The manuscript describes incremental improvements in an instrument for the measurement of ambient O₃ from aircraft via UV absorption. It builds on the decades-long heritage of a well-respected instrument deployed by NOAA. Novel improvements include the use of polarized light to fold the optical path thereby improving instrument precision for a given physical cell length. The authors were able to achieve slight reductions in instrument size and weight, while maintaining, or slightly improving, instrument performance. It appears to be a very nice instrument, though it is clearly an incremental improvement using good ideas, as opposed to totally novel approach. The overall quality of the manuscript is very high. The instrument and its performance are thoroughly described. I recommend publication essentially as is, though I suggest that several minor modifications be considered.

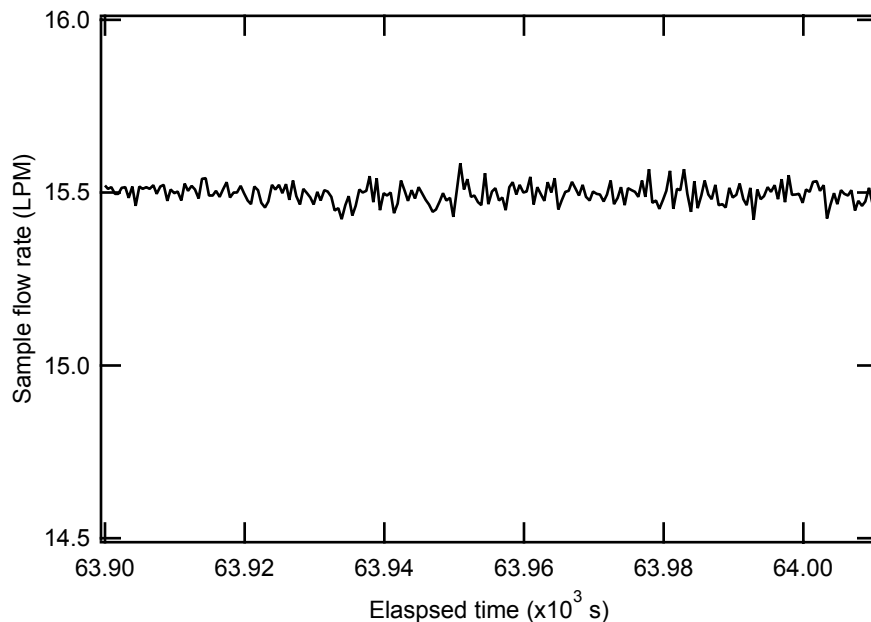
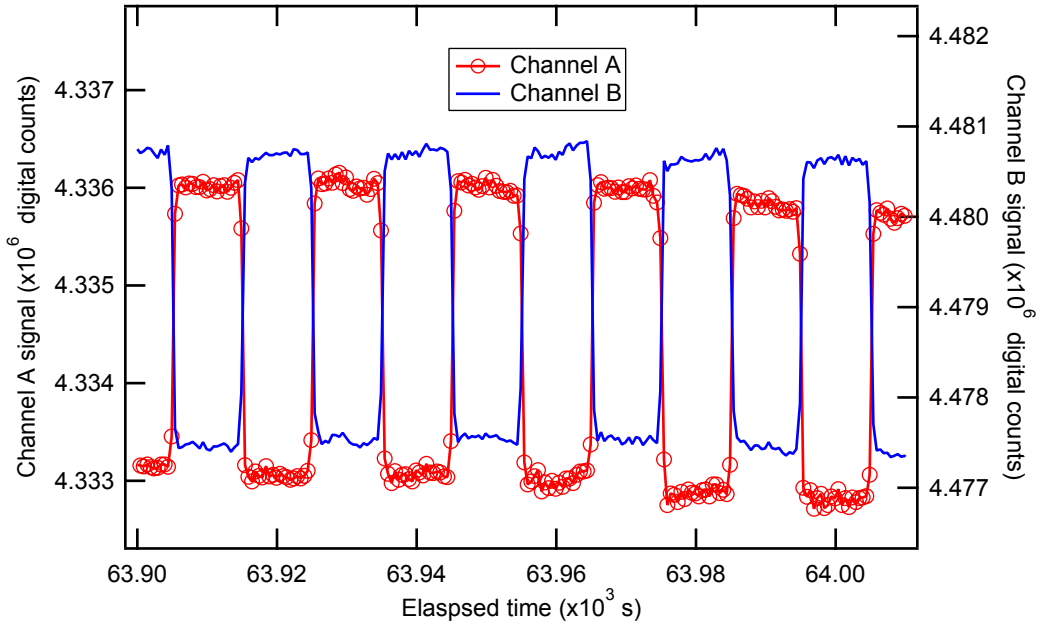
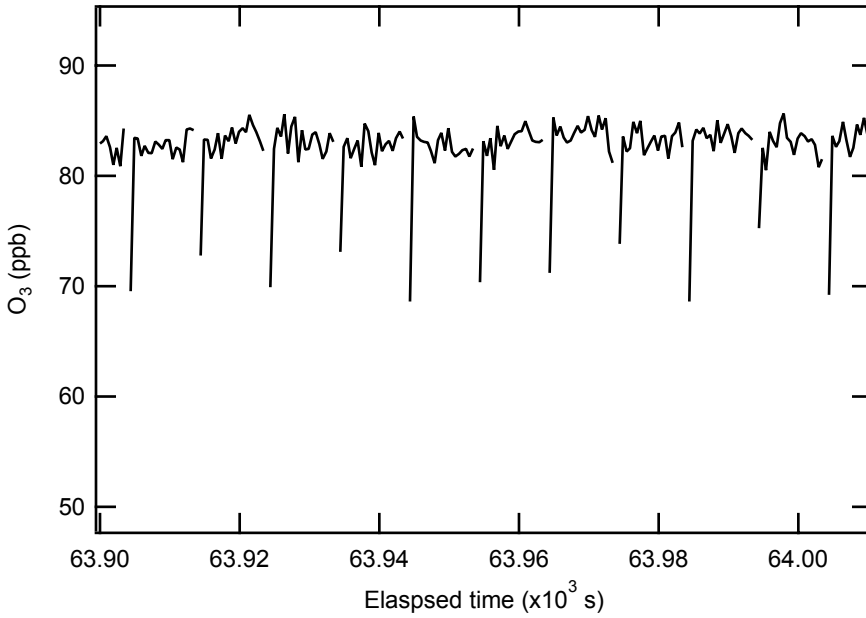
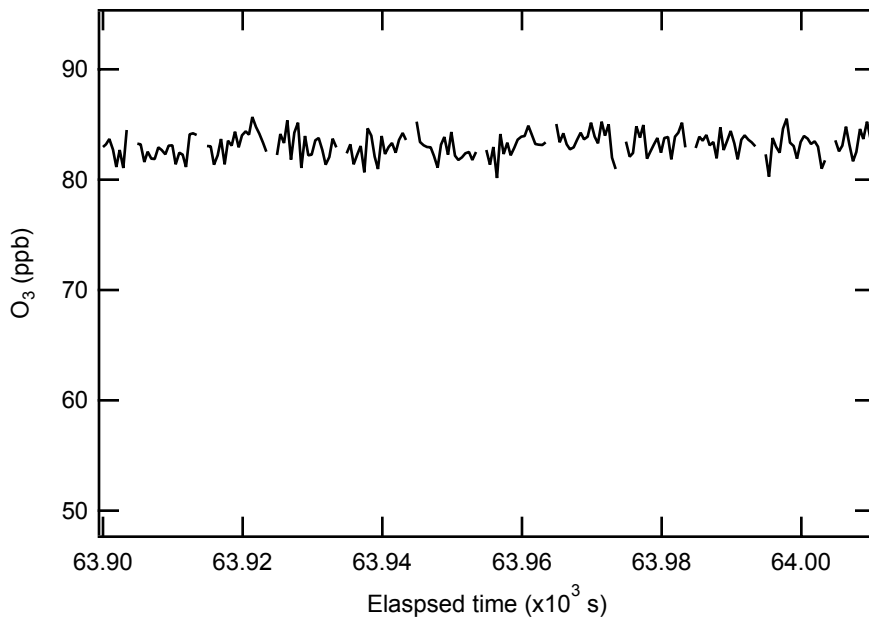
(8) Also related to (5) above: I am concerned about a potential negative bias from this technique that results from a lack of plug flow, and the potential for some scrubbed air to remain in the sample cell while the absorption measurement is being made. Can the authors relieve me of my concern? It seems to me that it might take a few times the plug-flow time to really purge the cell of all the scrubbed air, yet a shorter time is used (p3479, lines 9-12). How is the required flow for a true flush time determined? Are the PDs sampled at a high rate and leveling-off looked for? Is this done in flight to insure the quality of flight data?

> Incomplete flushing is always a concern. Fortunately, the general data reduction algorithm described in Proffitt and McLaughlin (1983) makes the problem obvious in the O₃ mixing ratio results. An example is given here: The flow rate was at 15.5 LPM as shown in Figure 1. Count rates for both channels are shown in Figure 2. In either channel the counts are higher without O₃ in the cell (scrubbed air), and lower with O₃ in the cell. Channel-A data clearly shows counts in transition after valve switch (in this case there are two data points for each switch) before reaching a new stable reading. These data points in transition should be discarded because of incomplete cell flushing. Figure 3 shows the result of insufficient data exclusion (only one point instead of two). A clear reduction in calculated O₃ values is visible after each valve switch. Sufficient data exclusion (two points) results correct O₃ values (Figure 4).

In the interests of length we have added a sentence that points the reader to the Proffitt et al. discussion of this aspect.
